## Schemes Planning and Delivery Team working in Partnership with Horsmonden Parish Council Highway Improvement Plan

### HIP Front Cover

### Live Priorities Record

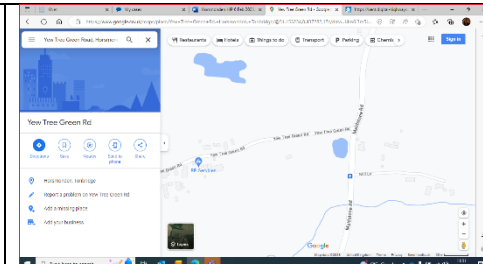
<p><b>19.01.23</b> - TG emailed Parish Council to confirm that, in theory, it would be possible to install bend warning signs on this road. However, we will require specific locations, as there are several bends on this road. We can then examine the specific proposals and establish viability.</p> <p><b>06.03.23</b> - Parish Council confirmed that they would like a sign on the bend before RP Services and ahead of the first bend, travelling away from Maidstone Road (screenshots below):</p> 
--	--	--	--	---

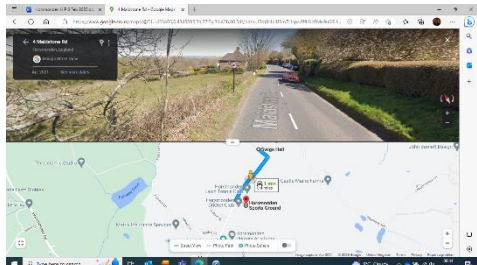
<p>carriageway at the below locations on Yew Tree Cross Road. Parish Council asked to confirm that they are happy with the proposals and ET will raise the job and fund.</p>  <p>Yew Tree Cross Road</p> <p><b>17.07.23</b> - Parish Council confirmed that they are happy for KCC to proceed with the proposed scheme. The Design &amp; Delivery Team have been asked to complete the design and raise the order with the contractor.</p> <p><b>Update 04.09.23</b> - The Parish Council received concerns from a resident over the location of the signage. This has been shared with the Design &amp; Delivery Team who have been asked for a copy of the drawings outlining the exact sign</p>
--	--	--	--	---

locations that ET can share with the Parish Council.
--	--	--	--	--

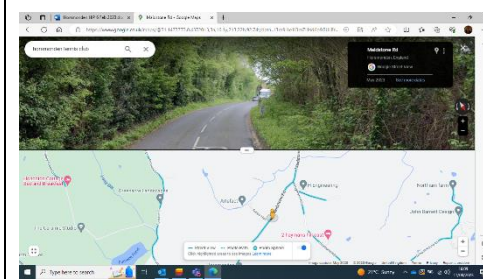
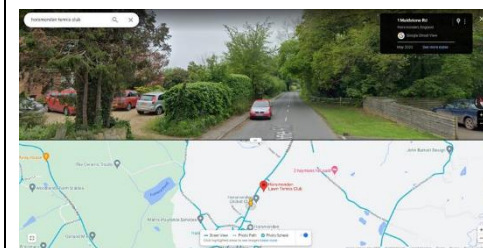
<p>review and a detailed breakdown of the findings has been shared with the Parish Council (“Planning and Advice response - Maidstone Road, Horsmonden (12409480)”). Ultimately, KCC consider that the existing 40mph speed limit is appropriate for the location and would appear to be well observed. The location does not meet the criteria for a 30mph and is also likely to receive poor compliance judging by the results of the recent traffic survey.</p> <p>However, we appreciate that there are concerns about the lack of footway at this location. Whilst we would be unable to look into installing a footway here, there is opportunity to install some “pedestrians in road” warning signs, with complementing SLOW markings on the carriageway.</p>
--	--	--	--	---

<p>There is a footway which terminates near to the 40mph terminal sign and doesn't pick up again until the houses further up near Swigs Hall so we would look to install a sign at each end with a distance plate ("no footway for ... yards") to indicate to drivers that there is no footway here.</p> <p>Proposed locations are as follows:</p> <p>On the existing pole with 40mph repeater sign, just before Swigs Hall, from the direction of Rams Hill.</p>  <p>On the grass verge just before the start of the 40mph, leaving the village,</p>
--	--	--	--	---

<p>on the right-hand side (outside Maythorne).</p>  <p>Parish Council to confirm if they are happy with these proposals. KCC will fund.</p>
--	--	--	--	--

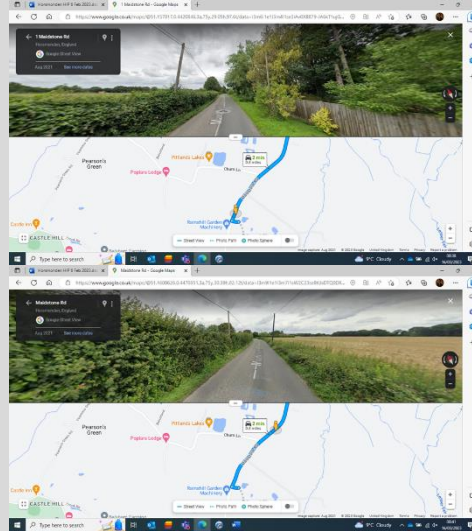
<p>those currently driving below 42mph may feel more inclined to drive to the posted speed limit.</p> <p>Parish Council would like a clearer overview of speeds at this location. ET to review suitable locations for two ATCs and to confirm with PC before arranging. KCC to fund.</p> <p>ET will also follow up with Ops re the refresh of line markings and update the Parish Council.</p> <p><b>16.03.23 -</b></p> <p><b>ATCs:</b></p> <p>Two locations for ATCs proposed as below (to be attached to telegraph poles at both locations). Parish Council to confirm that these would be suitable locations to get a good indication of vehicle speeds, and ET will arrange.</p>
--	---	--	--	--
